Subject: NOISE FROM FUEL TANK INSULATOR	Bulletin No: 01-010/15
	Last Issued: 12/14/2015

- This bulletin supersedes the previous bulletin 01-010/15, issued on 05/26/15. The APPLICABLE MODEL(S)/VINS and PART(S) INFORMATION has been revised.
- Changes are noted below in Red beside the change bar.

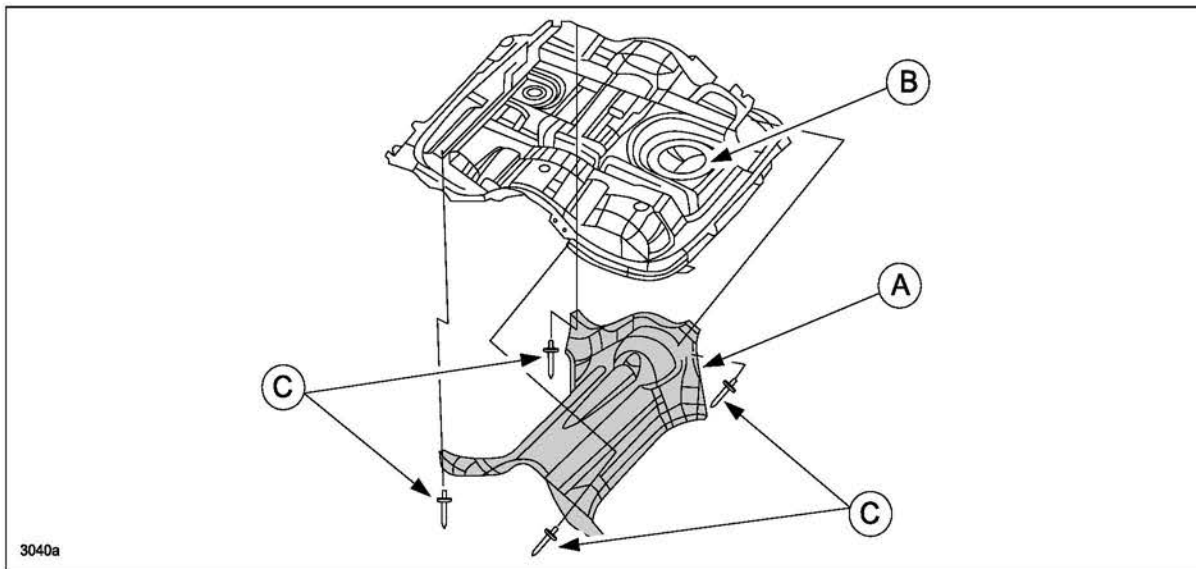
Some vehicles may exhibit an unusual noise while driving the vehicle. The noise may be caused by a broken fuel tank (B) insulator (A) that is hanging down and contacting the propeller shaft.

The rivets (C) may break when a load occurs. The rivet material has been changed to eliminate this concern. Customers having this concern should have their vehicle repaired using the following repair procedure.

5. Install the new insulator with modified rivets.
